### REMARKS

Date: December 19, 2005  
File No.: 7340-010

### **Amendments to the Drawings**

FIG. 1B

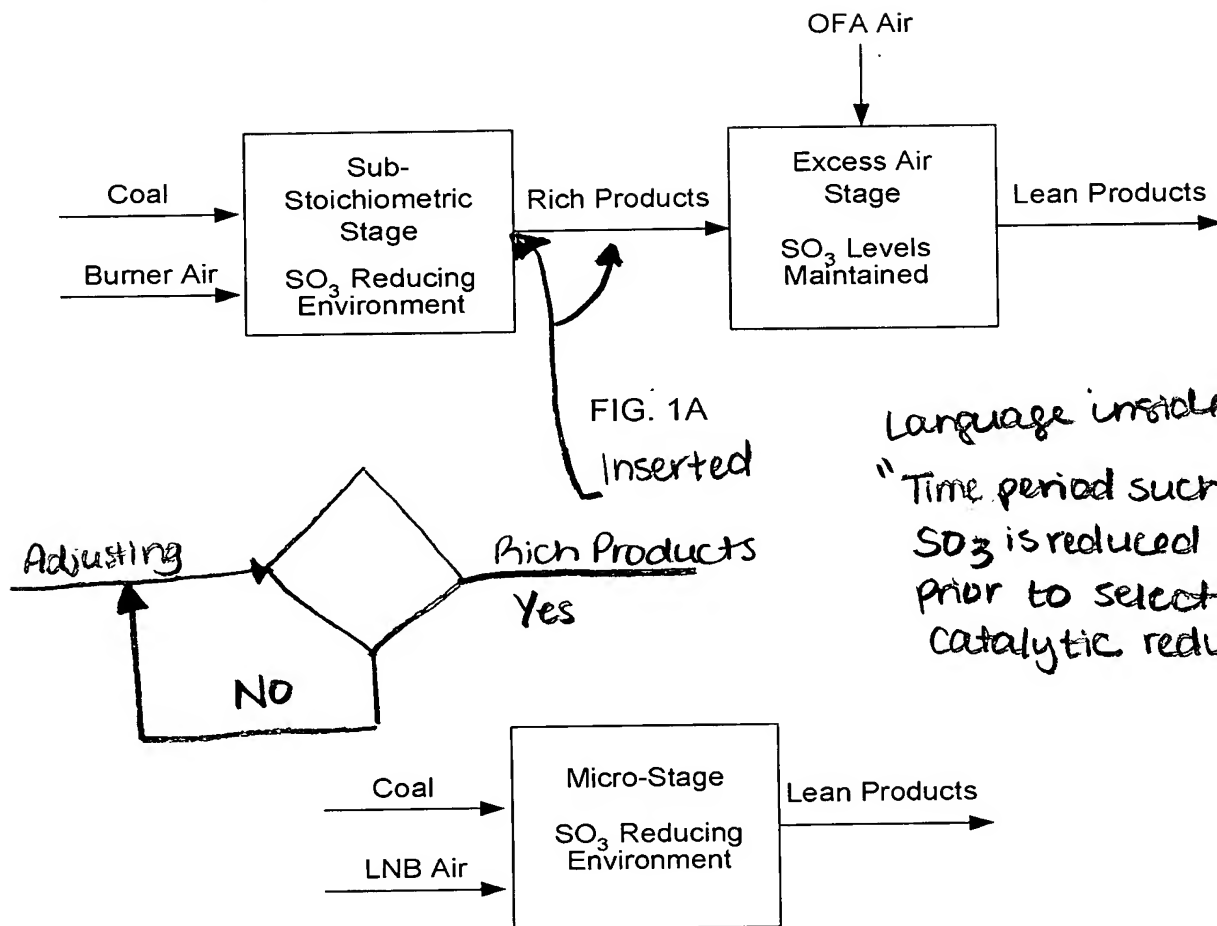
The Examiner objected to the Drawings for failing to show process steps for the entire claimed method including the SO<sub>3</sub>. The Examiner's suggested changes have been made. With respect to the drawings, the Applicant has amended FIG. 1A to show that the sub-stoichiometric stage is a SO<sub>3</sub> reducing environment; that SO<sub>3</sub> levels are maintained in the excess air stage; time period; and prior to selective catalytic reduction. Applicant has amended FIG. 1B to show that the micro-stage is a SO<sub>3</sub> reducing environment.

The attached sheet of drawings includes changes to FIG. 1A and FIG 1B. This sheet, which includes FIG. 1A and FIG. 1B replaces the original sheet including those figures. No items have been omitted.

\* Changed view to landscape.

Language inside   
"Time period such that  
SO<sub>3</sub> is reduced to SO<sub>2</sub>  
prior to selective  
catalytic reduction?"
